has permission to Add new 60' x 100' accessory building. City of Portland

RE: Review Comments for Final Plan – Administrative Review

On **April 7, 2010**, the Portland Planning Authority approved a minor site plan for a 6,000 Sq Ft Accessory Building at 501 Danforth St. as submitted by the Applicant and shown on the approved plan prepared by **Stephen R. Bushey, P.E. Deluca-Hoffman Associates, Inc.** and dated 4/1/10 with the following conditions:

ACCESSORY BUILDING 501 DANFORTH STREET PORTLAND, MAINE SITE PLAN APPLICATION SUBMISSION

ACCESSORY BUILDING 501 DANFORTH STREET		DALUCA-HOFFMAN ASSOCIATES, INC. 70 BROAD STREET, SUITE 5 SOUTH PORTLAND, ME 04106 WWW.DALUCA-HOFFMAN.COM
	SITE LAYOUT AND UTILITY PLAN

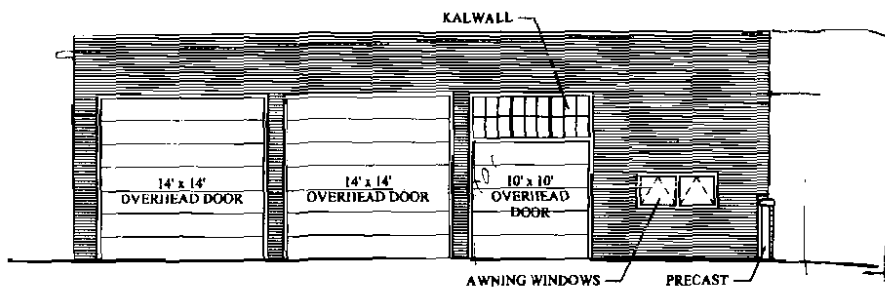
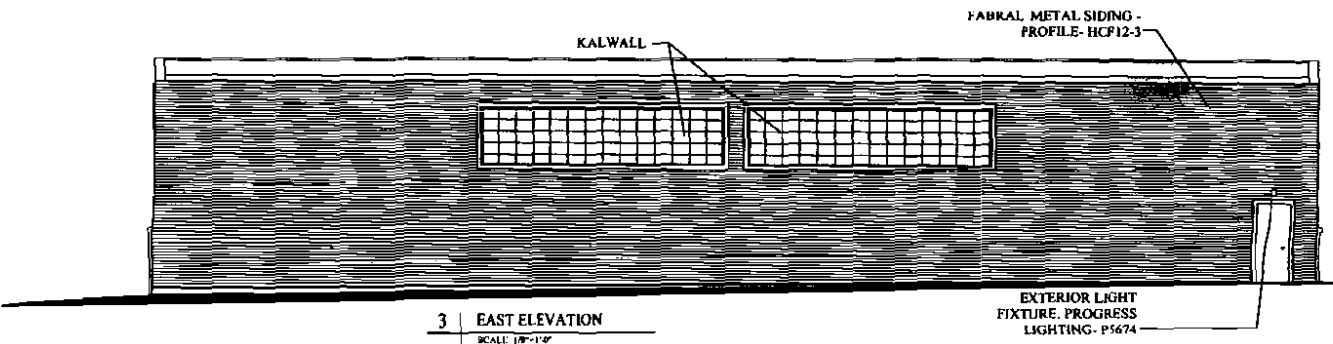
→ zoning analysis on site plan is not correct - should be corrected

I noticed that the submitted site plans show a Zoning analysis block that is not correct. That block that shows up in several places must be corrected.

Thank you for calling our attention to the inaccuracy on the site plan concerning the information shown on the Zoning analysis block. We will ensure that this is corrected on our revised plan.
